PROPERTY CONDITION REPORT

ADA042822XYZ

Report for: I. M. Client

Inspection Address: 141 South Dugger Ave., Roberta, GA 31078. The building faces southwest.

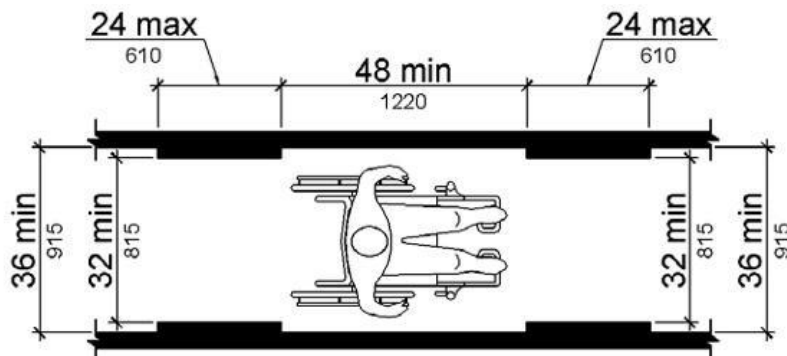
Item 3. One walkway from the front entrance toward the rear entrances is not 36 inches minimum in width and the walkway along the south end of the facility has excessive cross-slope. See the photo on the right.

The walkway connecting the front walkway to the south side walkway is not 36 inches in width. In some locations this walkway is 35.5 inches in width. See the photo on the left.

RECOMMENDATION: Consider increasing route widths to 36 inches, where feasible, and reducing cross-slope to 2.08% or less. This is important for daily access under normal conditions and also for emergency egress.

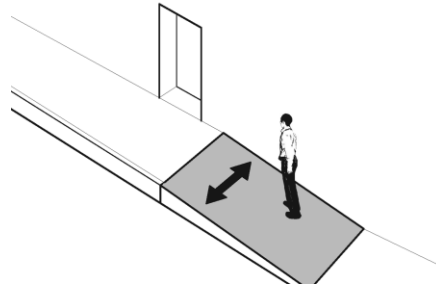
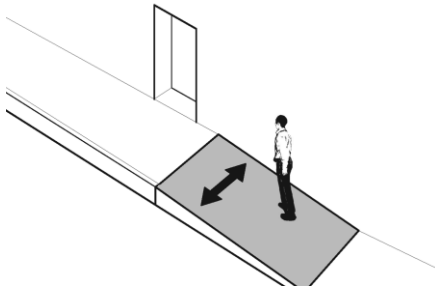
The walkway that runs along the south side of the facility has a cross-slope greater than 5% away from the building. See the photo on the right. This is particularly significant in this location due to the immediate proximity of the vehicular way adjacent to this walkway.

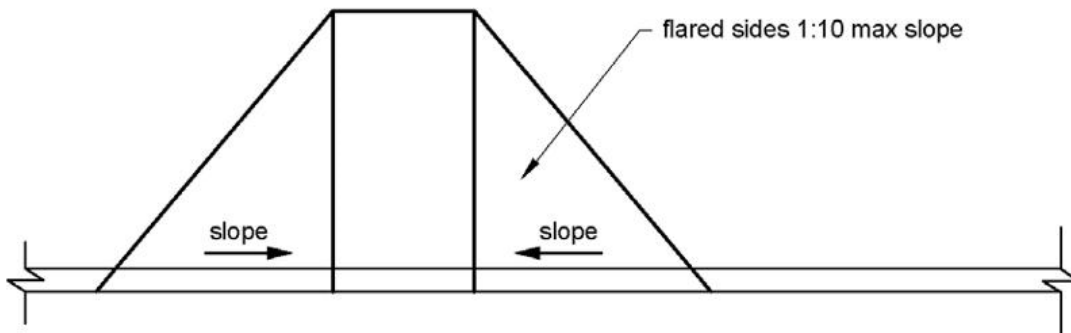
Item 5. The curb ramp for the existing ADA accessible parking space aisle has curb ramp flares that are sloped too steeply and a rough transition at the asphalt. See the photo on the right. The red arrows show the flares and the yellow arrow shows the transition.

The curb ramp flares are sloped at significantly greater than 10%. The photo on the left indicates a slope of approximately 35%. The opposite flared side was sloped at approximately 17%.

RECOMMENDATION: If this curb ramp is to remain, the curb ramp and transition should be replaced or repaired to comply with the ADA Standards. See item 6 below for related information.

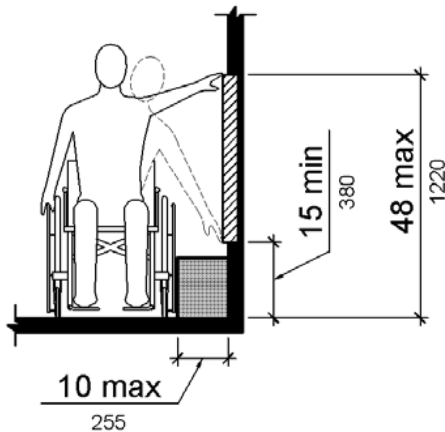
Item 8. The exterior depository in the first drive-through lane is installed more than 48 inches above the driveway. See the photo on the right.

RECOMMENDATION: Consider locating the depository within the reach ranges. For disabled individuals who access this depository without a vehicle, the height of the installation will make it difficult to use. This depository may be difficult for any individuals accessing this depository from a sitting position in a vehicle.

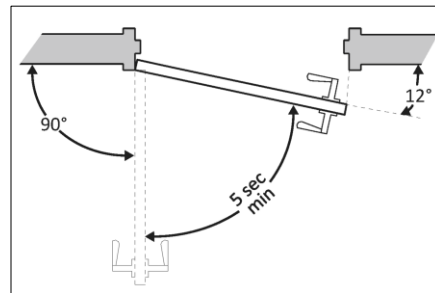
Item 9. The automated door marked with a temporary lawn sign for “Customer Entrance” does not have a guide rail on the swing side of the door and the manual side [left side from outside] of the door closes too quickly when released from the 90° open position. See the photo on the left. Looking from the outside, the right door is automated and the left door is manually operated. The automated door is a full-powered

The manually operated door closes too quickly (3.82 seconds). See the photo on the left.

RECOMMENDATION: Install the correct guide rail(s) for the automated swinging door and adjust, repair or replace the manual door closer.

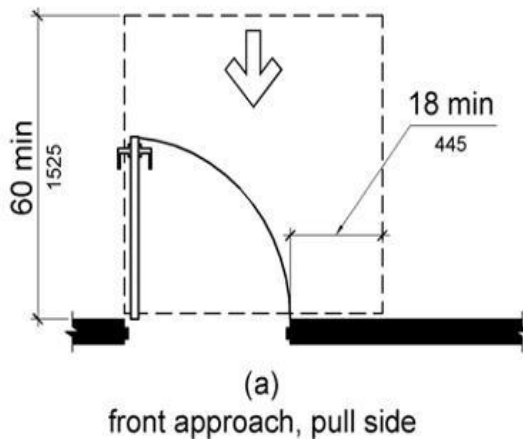
Item 11. The single door located at the rear northeast corner of the facility has several discrepancies including limited maneuvering space at the exterior and interior of the facility, the automated door closer allows the door to close too quickly, and the door opening space is narrow. See the photo on the right. This door swings out to open. This door is for employees only but us not marked as such.

The small size of the step system landing limits the maneuvering space on the outside (pull side) of the door and the interior step system to the 2nd floor compromises the maneuvering space required on the inside (push side) of the door.

RECOMMENDATION: Alter the door installation so that maneuvering space is provided on both sides, and adjust, repair, or replace the door closer, and increase the door opening width to at least 32 inches.

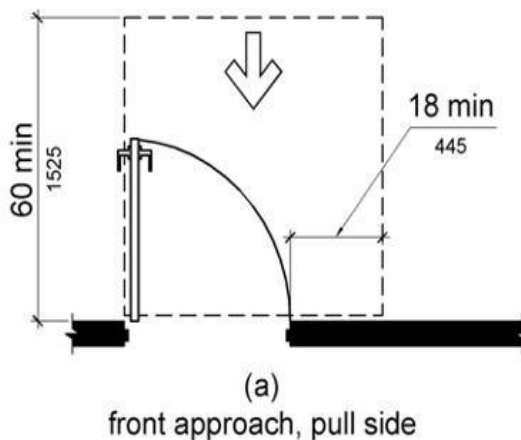
Item 15. The interior door in the employee work area on the north side of the facility that connects to the 2nd floor has compromised maneuvering spaces on both sides of the door and the door opening is too narrow. See the photo on the right.

This door leads to the stair system that goes up to the second floor employee break room and to the exterior pedestrian entry/exit single door at the northeast corner of the facility. This door is pulled to open from inside the employee work area and pushed to open from the staircase side.

RECOMMENDATION: Alter the interior door installation so that maneuvering space is provided on both sides of the door and the door opening width is at least 32 inches.

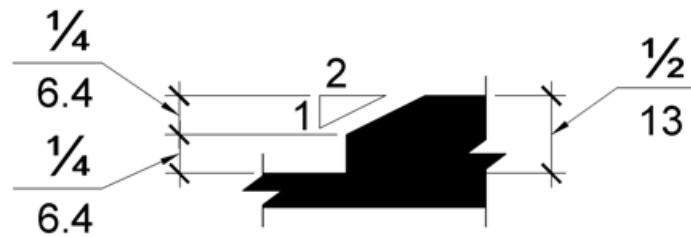
Item 19. Two vault door openings were observed with less than 80 inches vertical clearance and vault door thresholds too high above the finished floor. The photo on the right is representative where the height above the finished floor is approximately 78 inches to an object.

RECOMMENDATION: The doors for these vaults have been removed. There is no need for the thresholds. If possible, remove the thresholds and the objects at the top of the door openings to maximize door opening space and remove the tripping hazards associated with the thresholds.

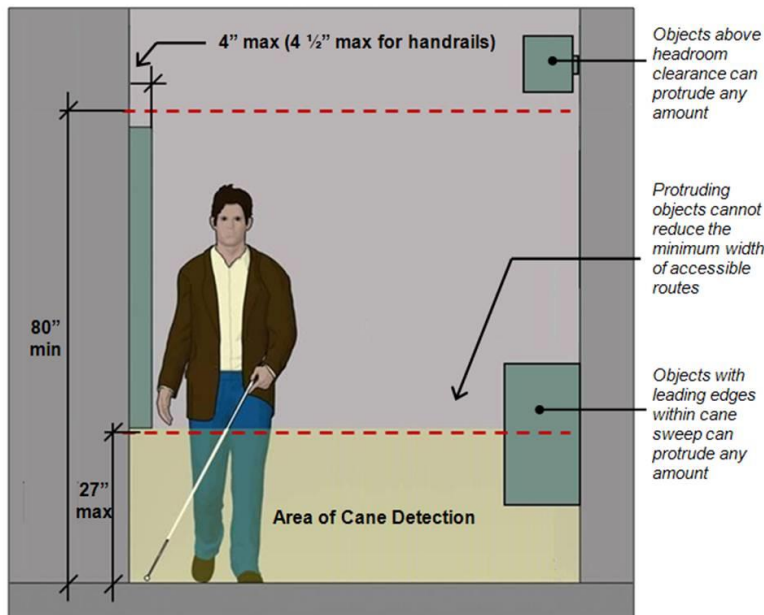
Item 20. A protruding object [fire extinguisher] was observed in the hall for the two toilet rooms on the first floor. See the photo on the right.

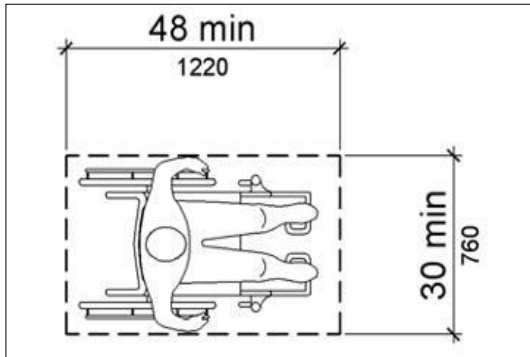
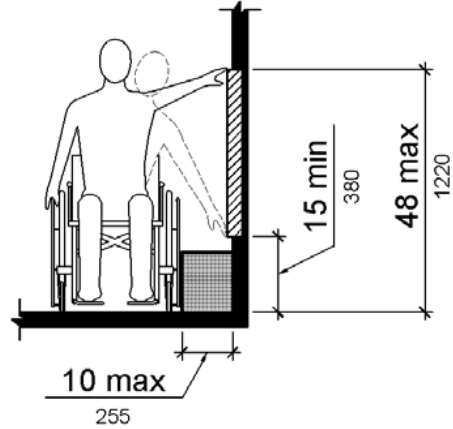
Item 21. Some wall mounted controls such as security panels, thermostats, and wall switches are mounted too high above the finished floor. The photo on the right is representative of a security panel mounted more than 48 inches above the finished floor.

The photo on the left is a thermostat that is mounted too high above the finished floor.

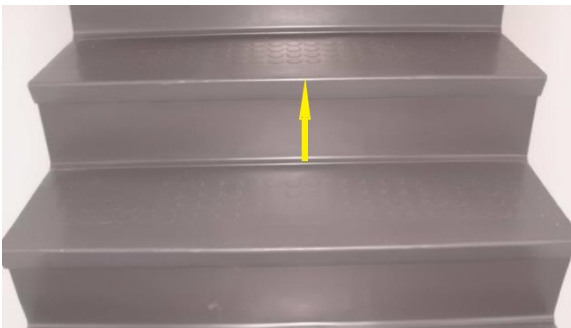
The steps have rise dimensions of approximately 8 inches. The photo on the left is representative.

RECOMMENDATION: If the second floor will have spaces, elements, or activities that employees or non-employees may access, consider providing access for disabled individuals as well. Options could include elevators and platform lifts, although these installations are not required for this facility, based on the current size and use of the facility. See Implementation regulation §36.401, New construction, (d) Elevator exemption (2), and Implementation regulation §36.404, Alterations: Elevator exemption, (a). The graphic below is representative of stair handrail installations.

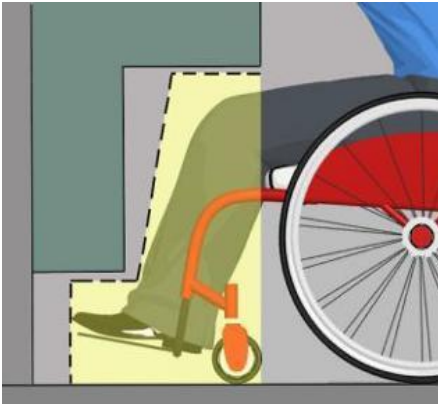
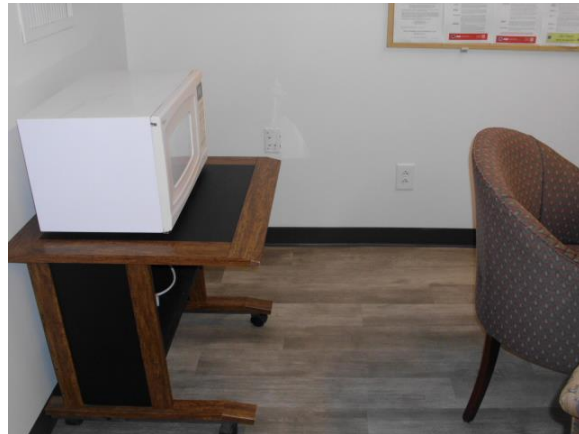
Item 23. The employee break room on the second floor has limited access to the dining table and microwave. See the photo on the right for the dining table.

This is a U-shaped kitchenette with only one pedestrian entry/exit point. The space between the microwave table and dining table/chairs is less than 32 inches. See the photo on the right. 2010 ADA Standard 804.2.2, [Kitchens and Kitchenettes] U-Shaped, states, "In U-shaped kitchens enclosed on three contiguous sides, clearance between all opposing base cabinets, counter tops, appliances, or walls within kitchen work areas shall be 60 inches (1525 mm) minimum." Also, accessible routes always require at least 32 inches route width and clear spaces with 30X48 inches of space at all elements.

RECOMMENDATION: Replace and relocate this dining table/chair. Although this table is not a fixed element, replacement is recommended based on the requirements for reasonable accommodations.

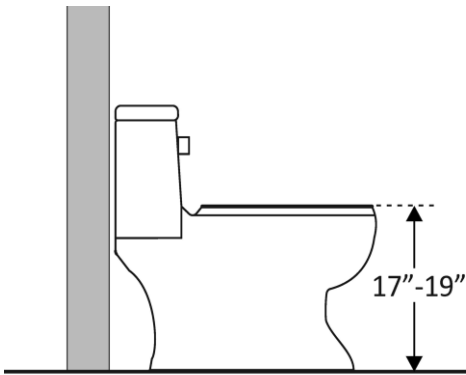
Item 30. The toilet seat height is too low to the floor and no toilet paper dispenser was observed. See the photo on the right of the toilet seat height.

RECOMMENDATION: Replace or alter the toilet installation to raise the toilet seat height and install a toilet paper dispenser.

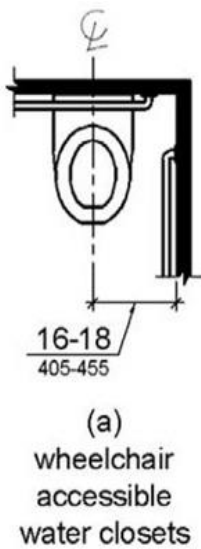
Item 38. In the first floor Women's toilet room the toilet is installed slightly too far from the side wall. See the photo on the right.
